CASE #PL2021-42

WALSER TOYOTA BLOOMINGTON, MN

Reviewed for Code Compliance
Date: 11/04/2022
By: K. Bayer
Plan # PRBD202210606

2022 NEW BUILDING FOR:
WALSER TOYOTA
4401 AMERICAN BLVD
BLOOMINGTON, MINNESOTA

CODE REVIEW

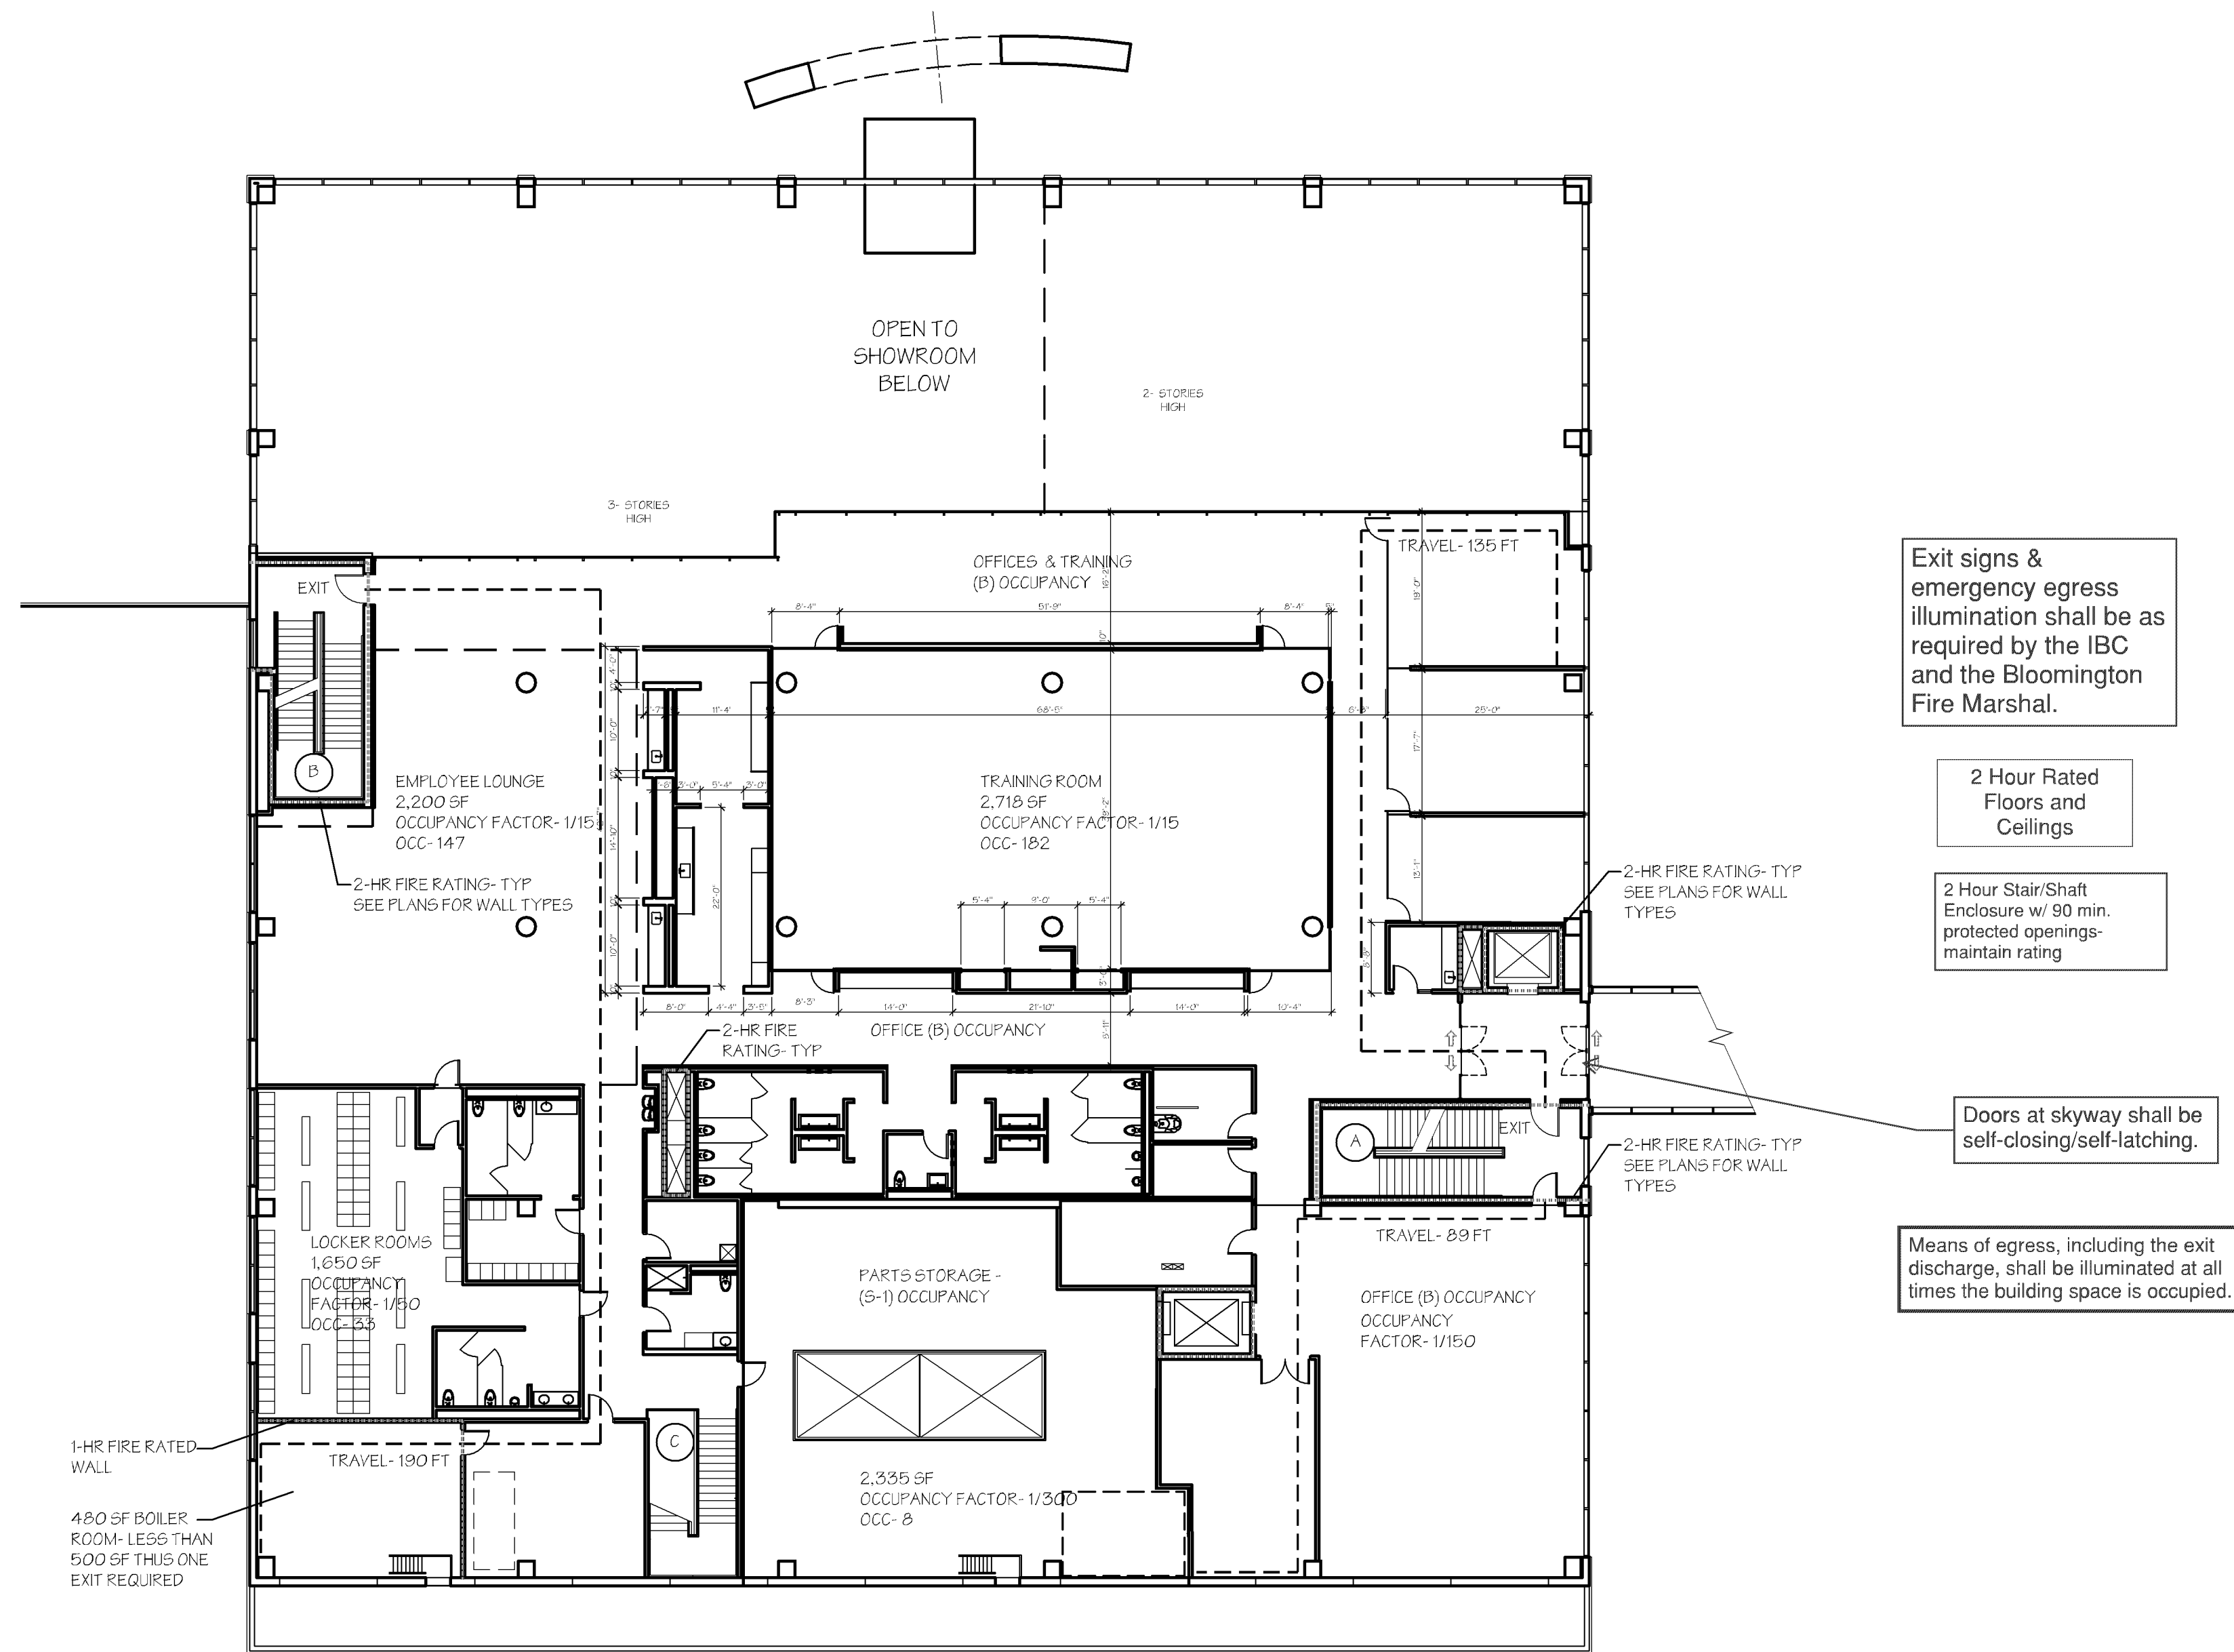
Exit signs & emergency egress illumination shall be as required by the IBC and the Bloomington Fire Marshal.

2 Hour Rated Floors and Ceilings
2 Hour Stair/Shaft Enclosure w/ 90 min. protected openings-maintain rating

2 SECOND FLOOR PLAN
1/16" = 1'-0" NORTH

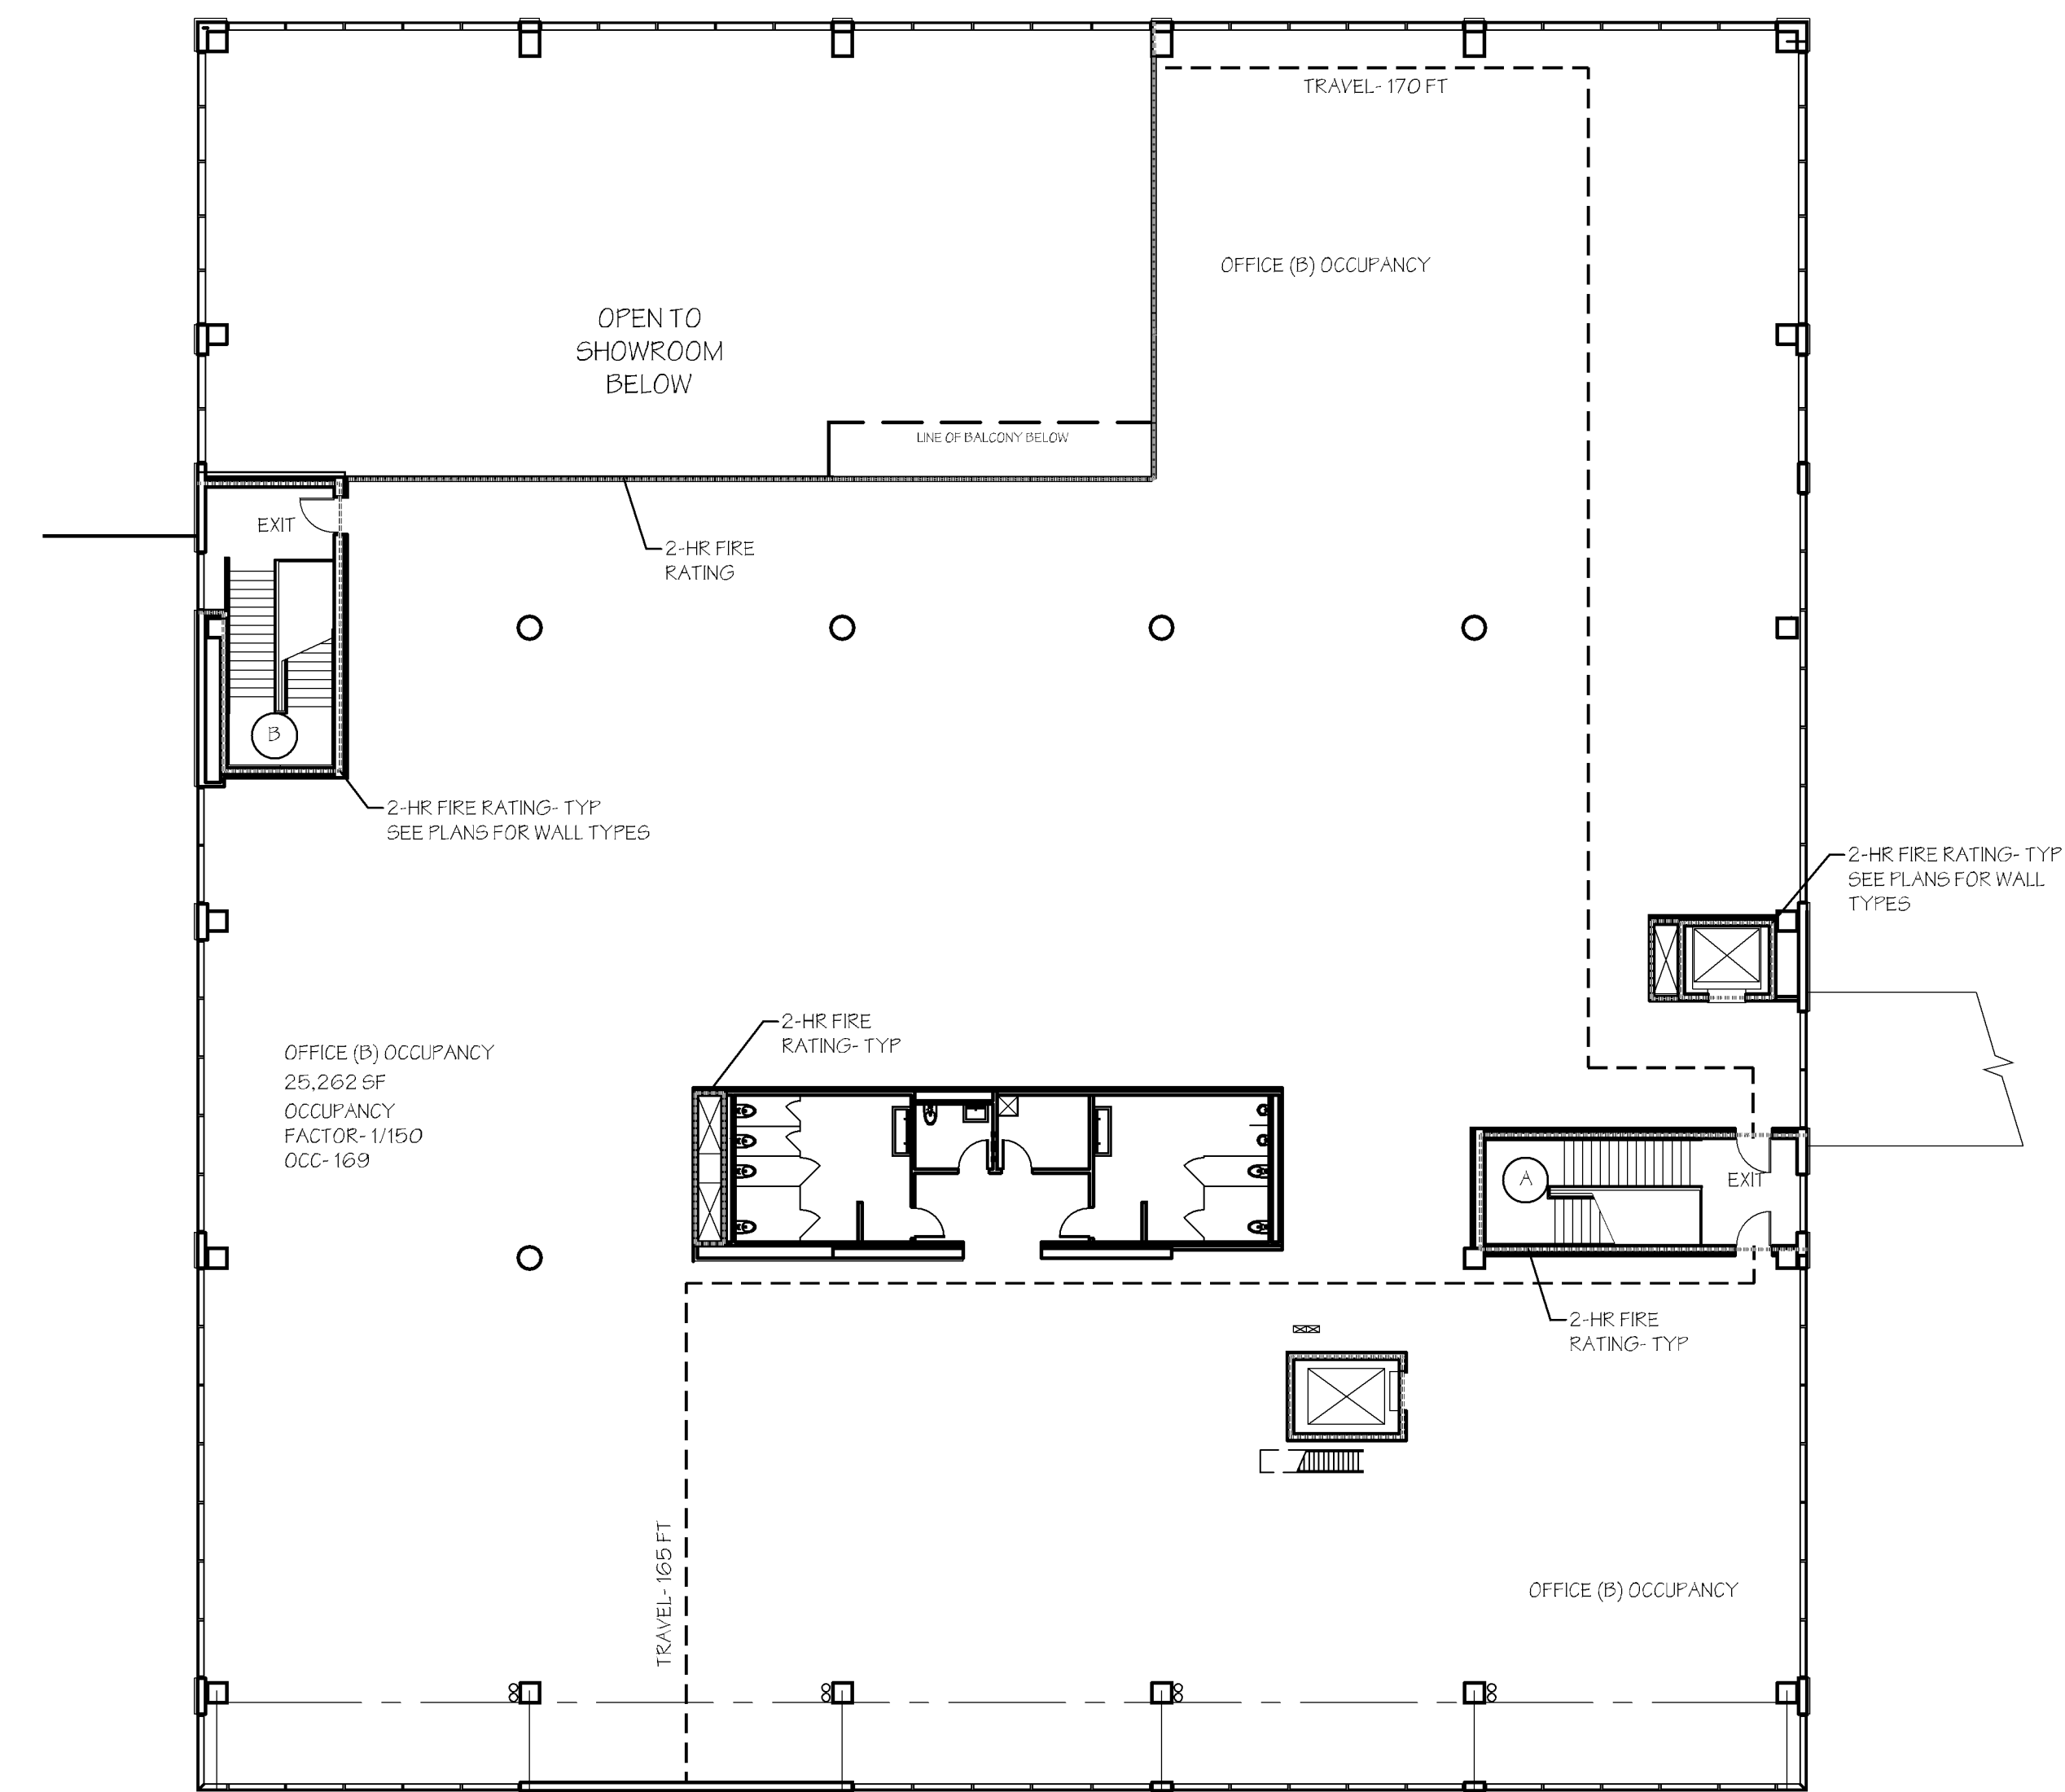
Exit signs & emergency egress illumination shall be as required by the IBC and the Bloomington Fire Marshal.

2 Hour Rated Floors and Ceilings

2 Hour Stair-Shaft Enclosure w/ 90 min. protected openings-maintain rating

Doors at skyway shall be self-closing/self-latching.

Means of egress, including the exit discharge, shall be illuminated at all times the building space is occupied.

1 SITE PLAN
1" = 30'-0"
NORTH

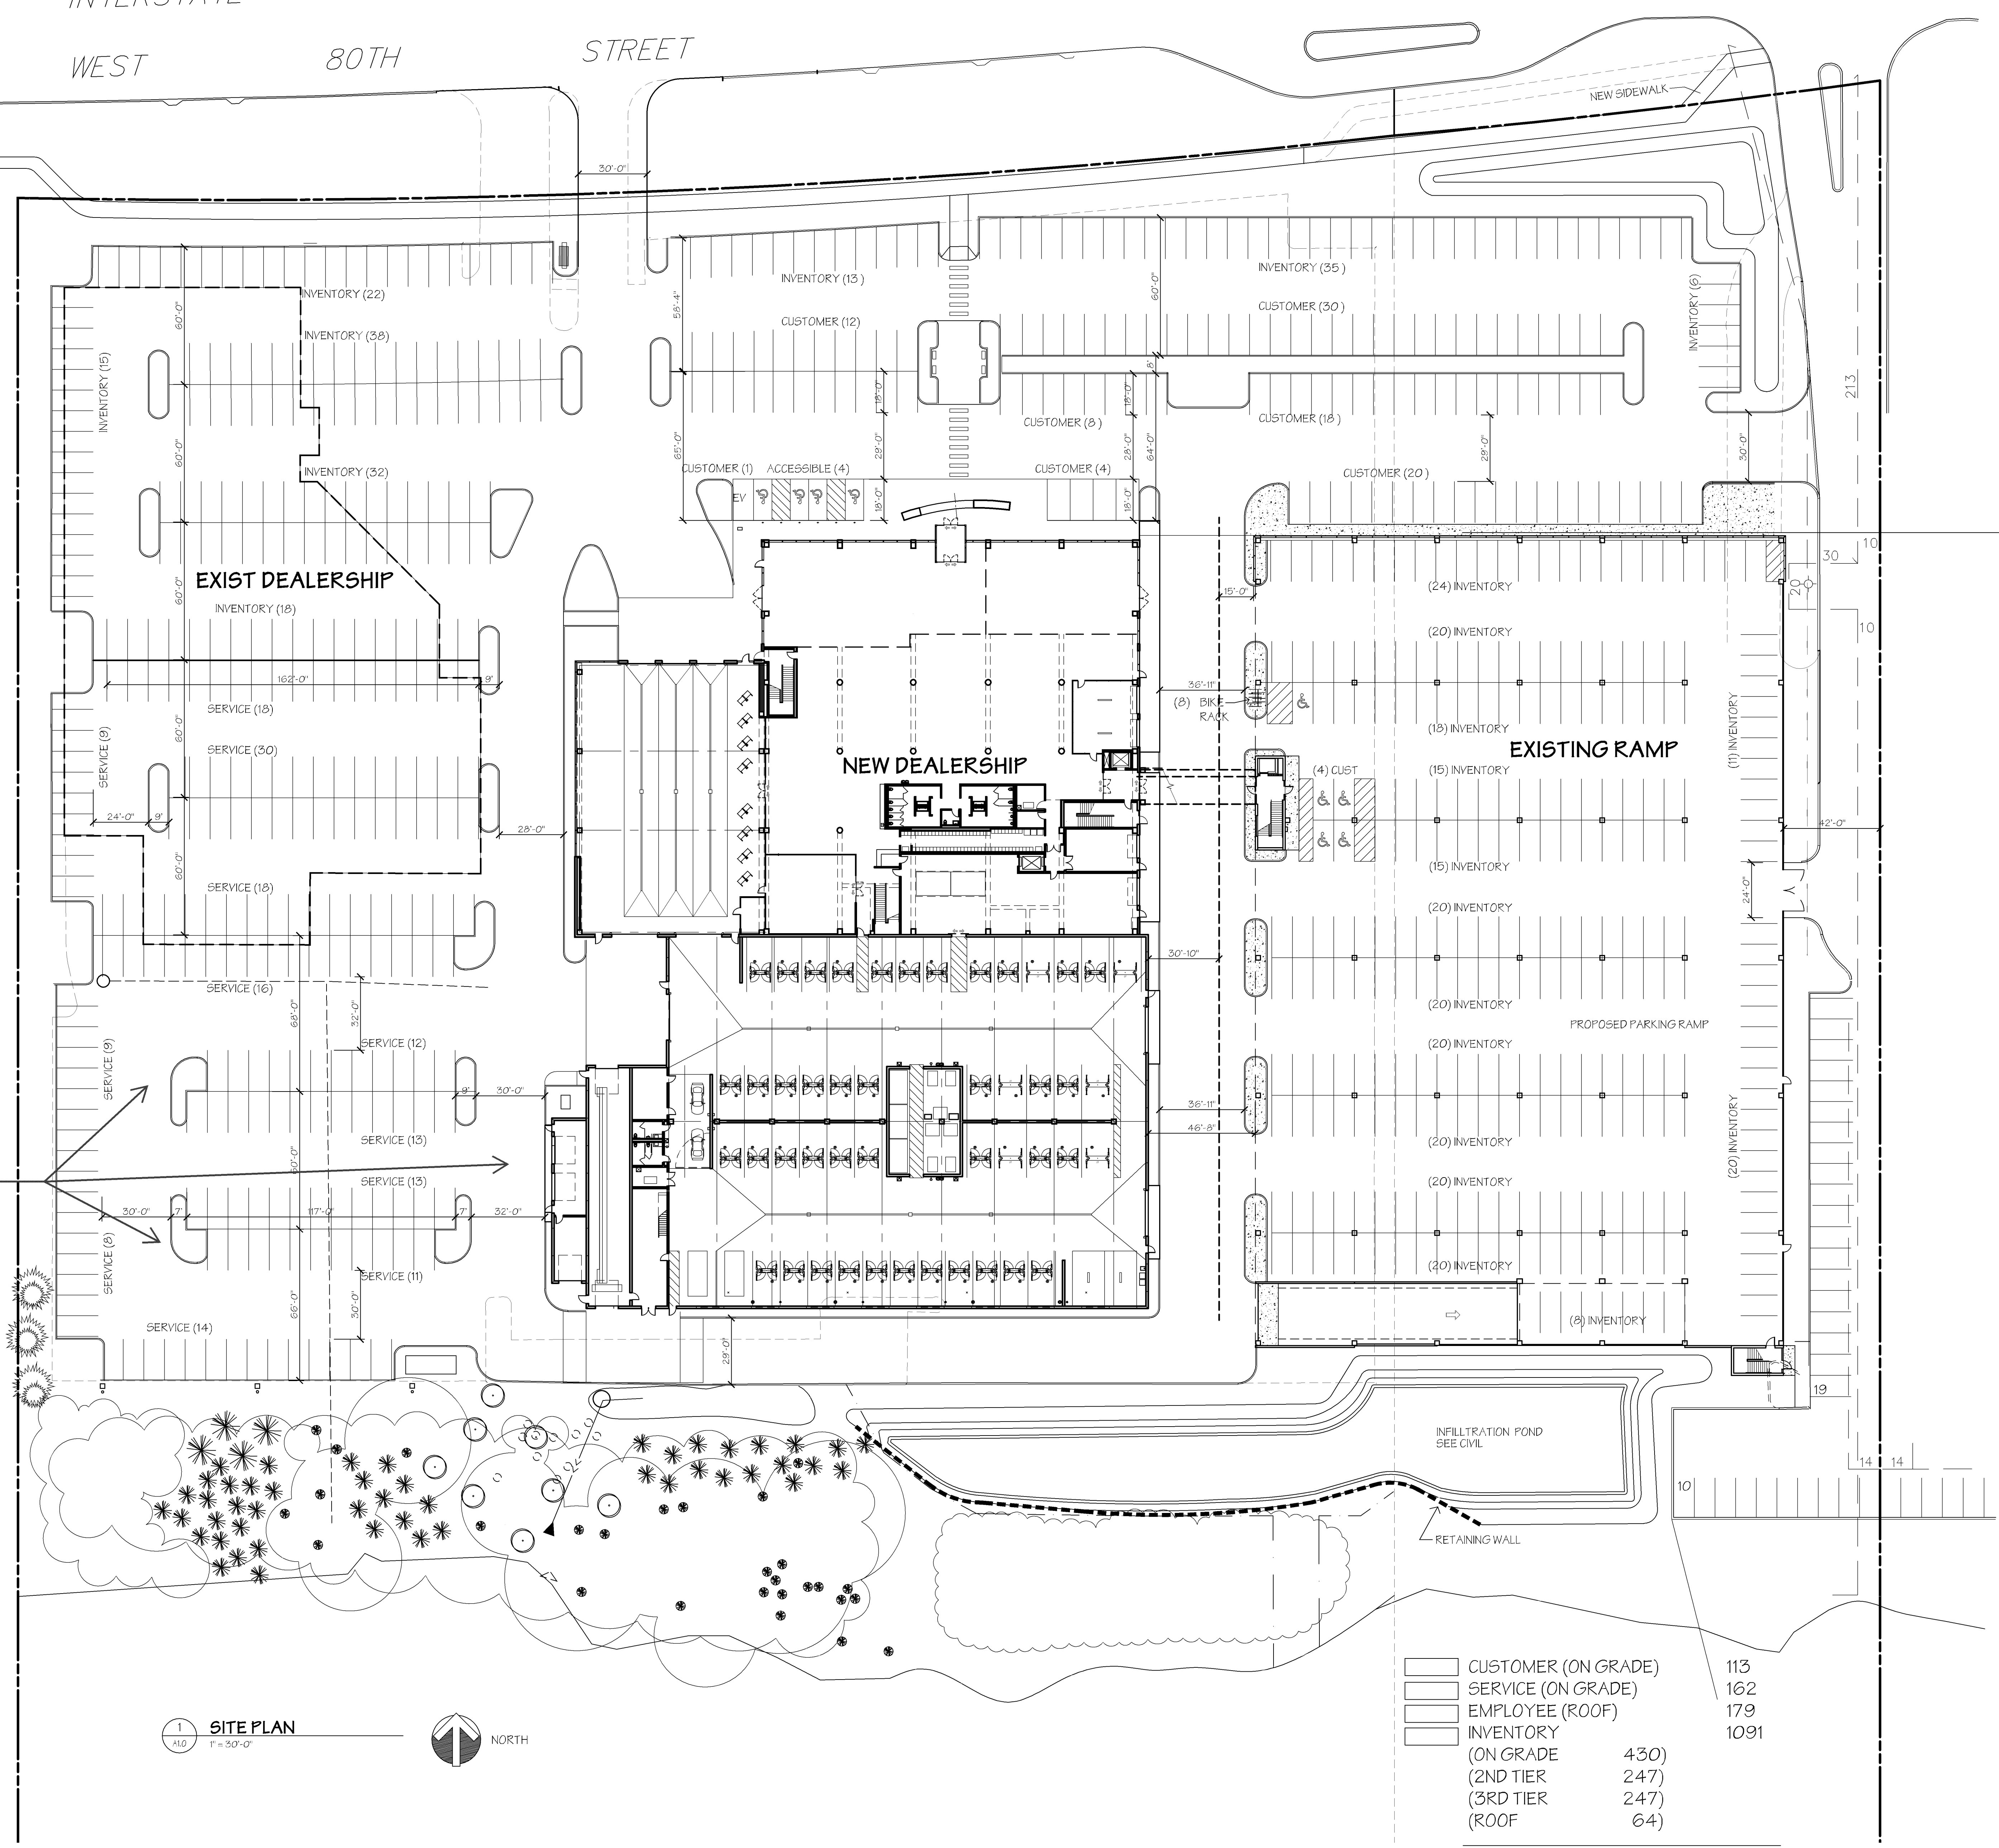
All accessible parking spaces for public use shall be 8'x18' and striped in white.
Provide required accessible stalls per 2020 MN State Accessibility code.
For every 6 or fraction of 6 accessible spaces, at least one shall be a van-accessible parking space.
Per 502.7 of 2020 MN Accessibility Code: Signs shall be centered at the head end of the parking space a maximum of 36 inches from the head of the parking space, and be mounted 60 inches minimum and 66 inches maximum above the floor of the parking space, measured to the bottom of the sign.
